LB/9762

12th of September 2024**Former Mather & Platt Foundry, Grimshaw Lane, Manchester, M40 2BA****Planning Application Number: 135454/JO/2022****Discharge Condition Reference: CDN/24/0682**

Please find below responses and accompanying information in relation to latest comments on the submission to clear planning condition 13 on surface water drainage.

Planning Condition 13

DRAWING No 9762-PTA-XX-XX-DR-C- 8103

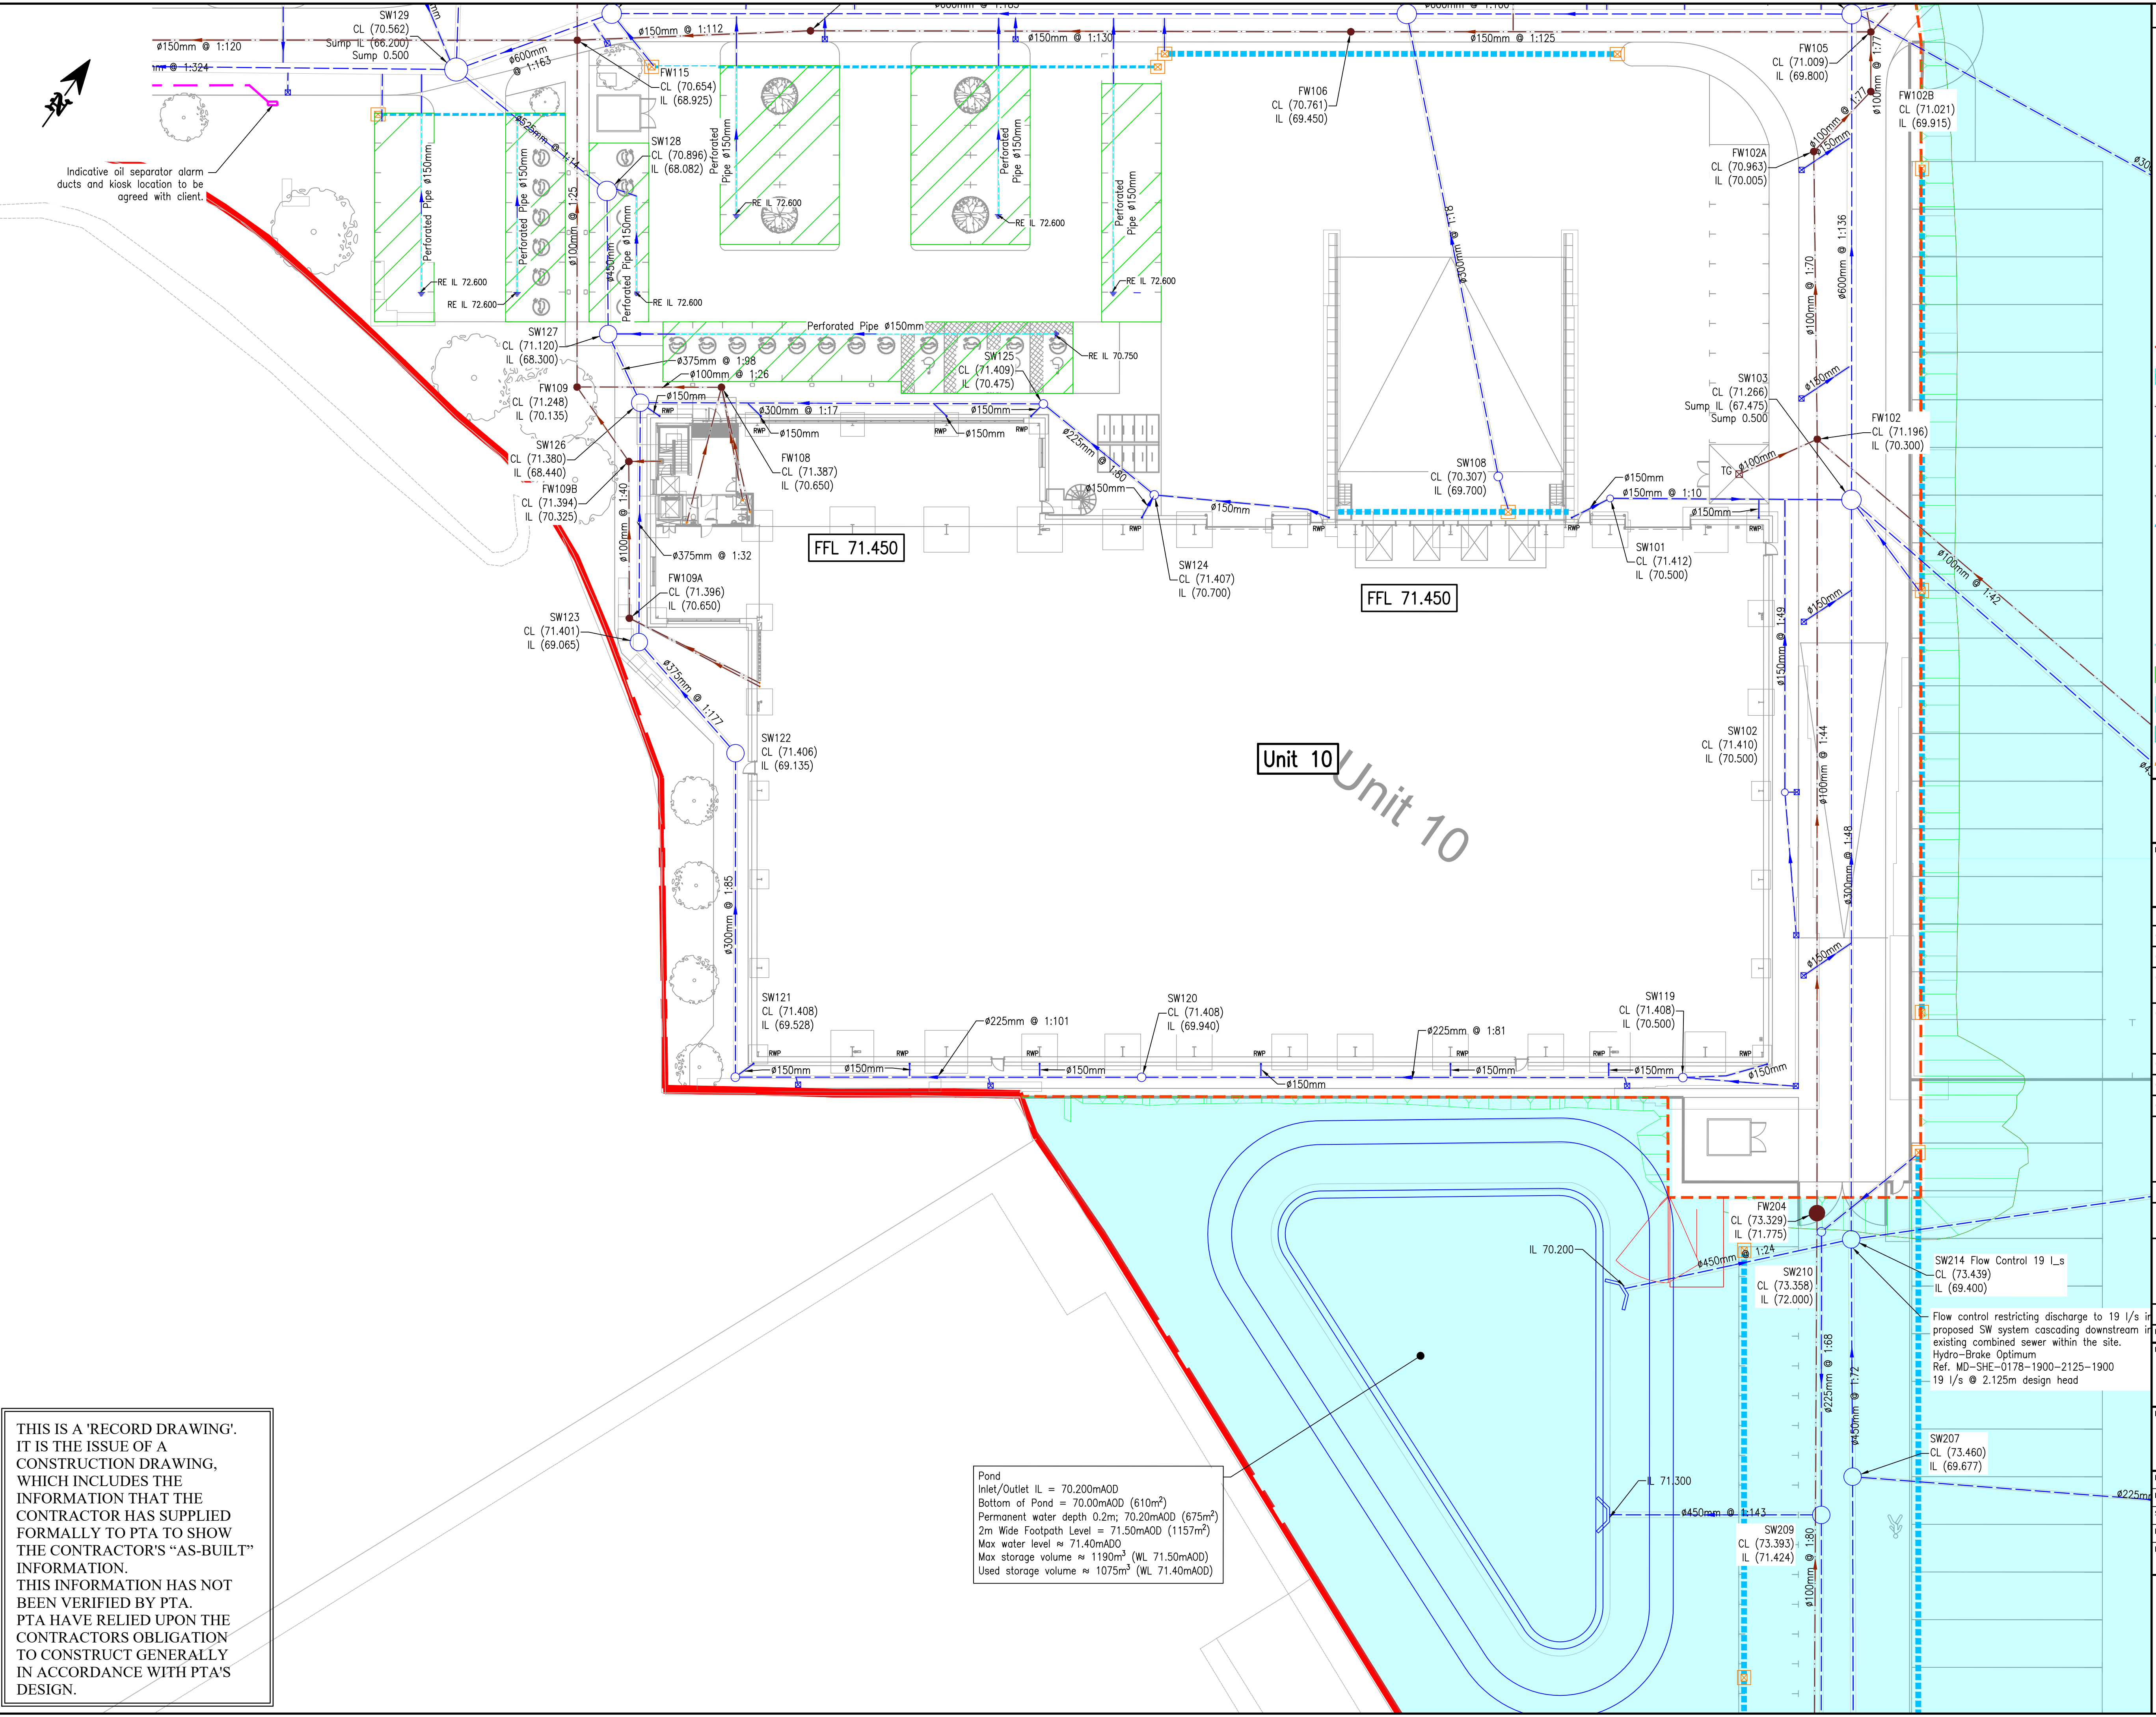
The developer needs to confirm drawing no. 9762-PTA-XX-XX-DR-C-8101, 2, 3 are the submitted as built details.

The developer must also provide the remaining four sheets, as the developer has currently only provided 1 – 3, out of a total 7 sheets.

We can confirm that the below referenced drawings represent the as-built drainage networks for development phase 1.

9762-PTA-XX-XX-DR-C-8103 - Proposed Drainage Sheet 3 of 7 - Rev C07

Sheets 4 to 7 of the proposed drainage layout show Phase 2 area which is not currently being considered for the discharge of this condition, and as such have not been included.

United Utilities Sewer Map

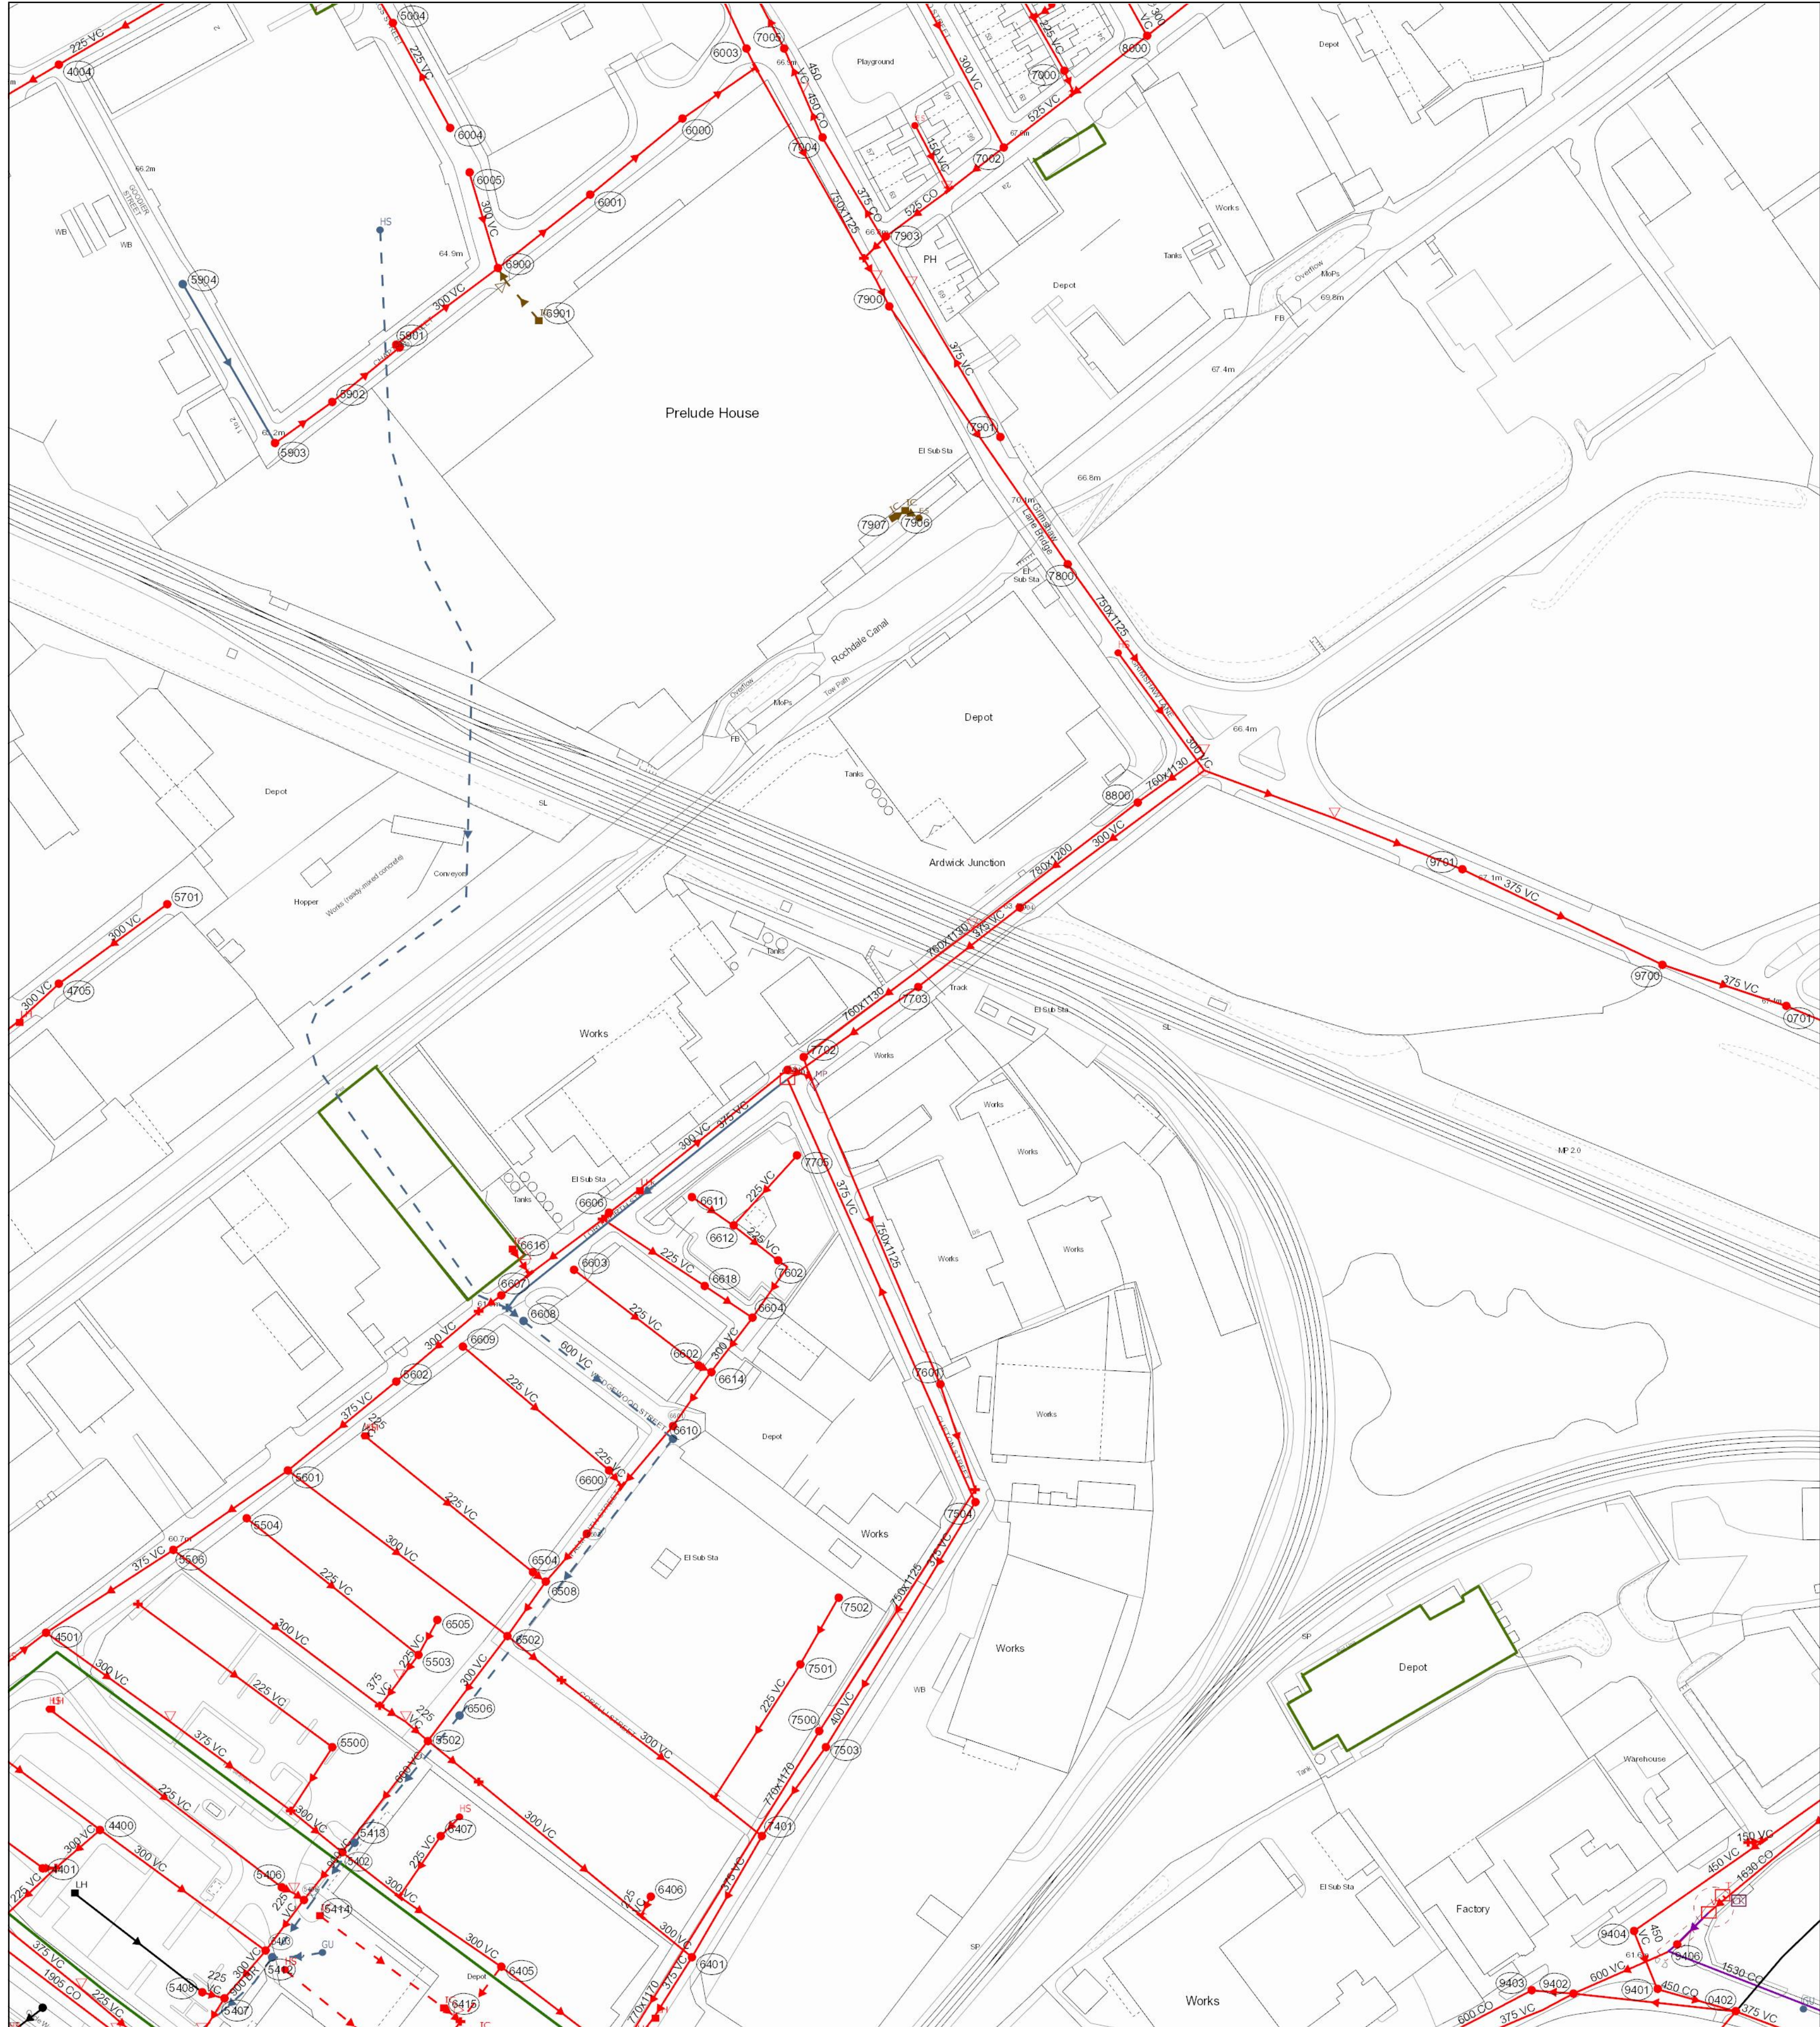
The latest engineering drawing no. 9762-PTA-XX-XX-DR-C-8101 now indicates a section of the 375mm combined sewer to be 'abandoned / removed'. The developer will need to provide an agreement in principle from United Utilities, this can be via email format.

This is a private sewer and as such no consultation/agreement with United Utilities is required. This ø375mm sewer is not shown on UU record asset map, see public sewer map enclosed. Also, the S106 consent has been granted for a connection through a private drain within private land, see S106 consent enclosed
